CITY OF HENDERSONVILLE
2026 STORMWATER IMPROVEMENTS MOUNTAIN VIEW ST, KANUGA RD, AND 4TH AVENUE

ADDENDUM NO. 1
December 18, 2025

Drawing No.
C-4

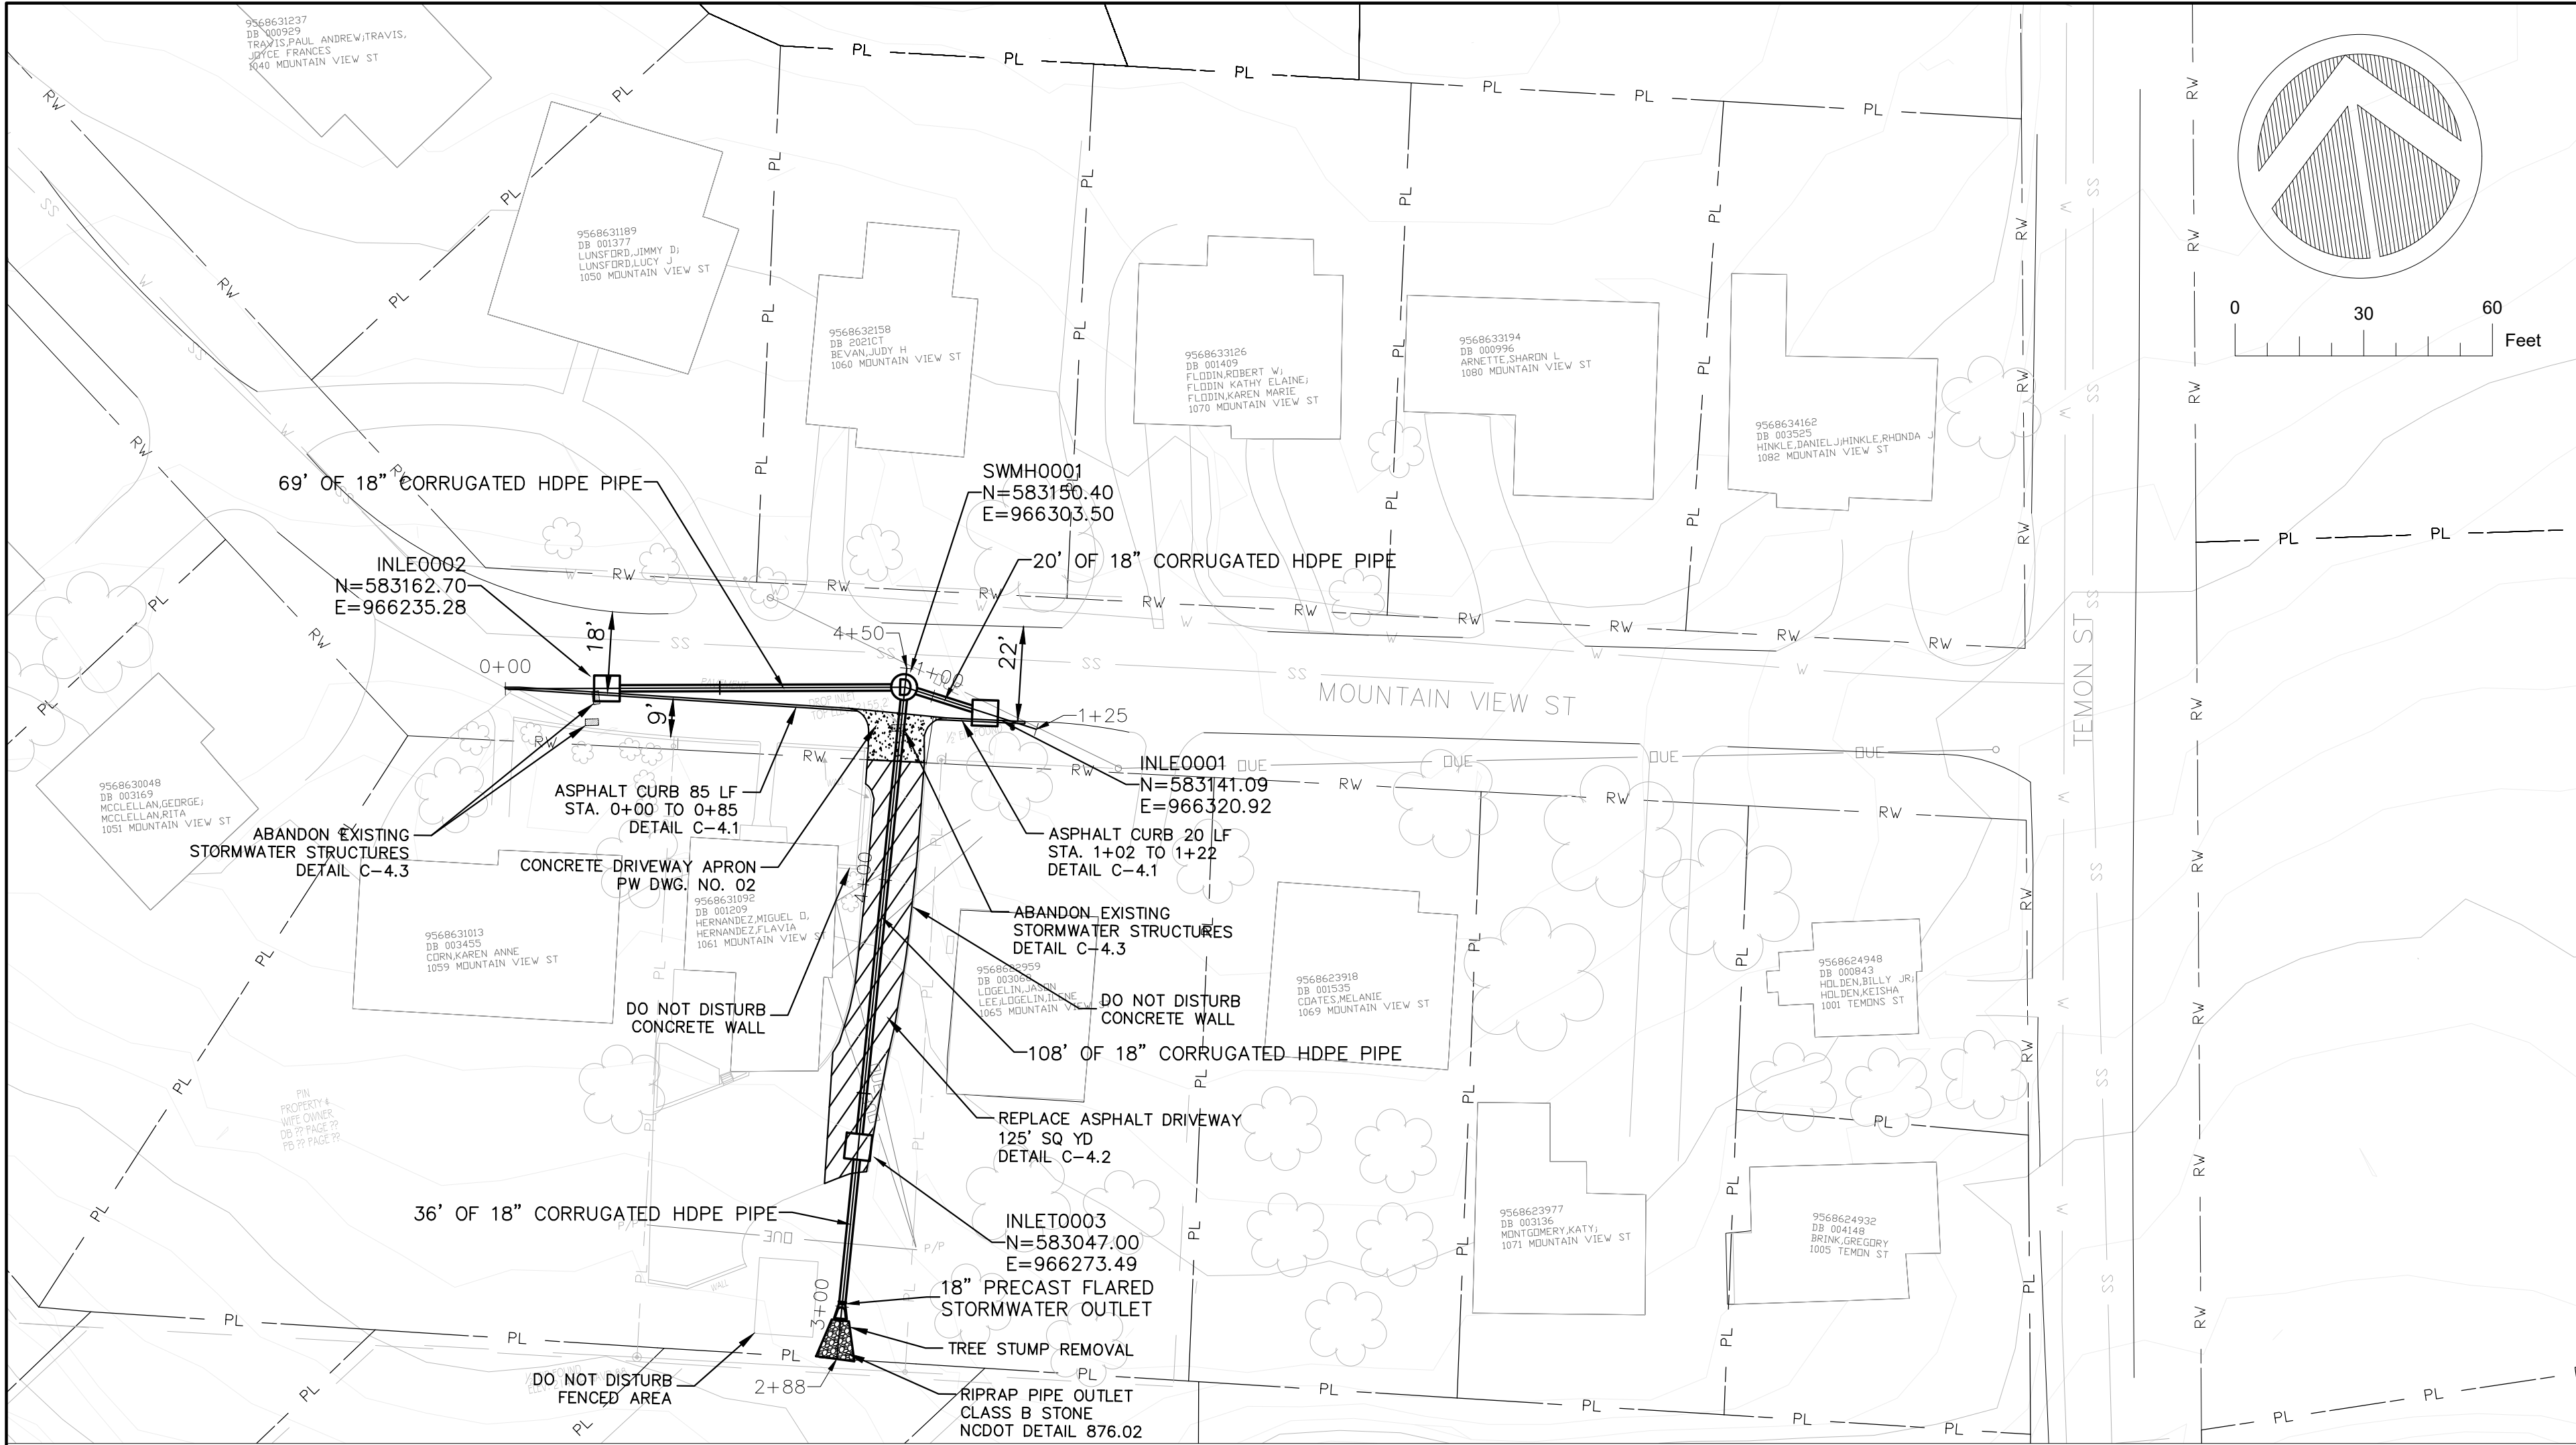
- Sheet C-4 has been revised to include modifications near the discharge location, including additional storm drainage pipe and tree stump removal.
- The plan set has been updated to include the applicable City of Hendersonville and NCDOT standard details referenced in the plans.
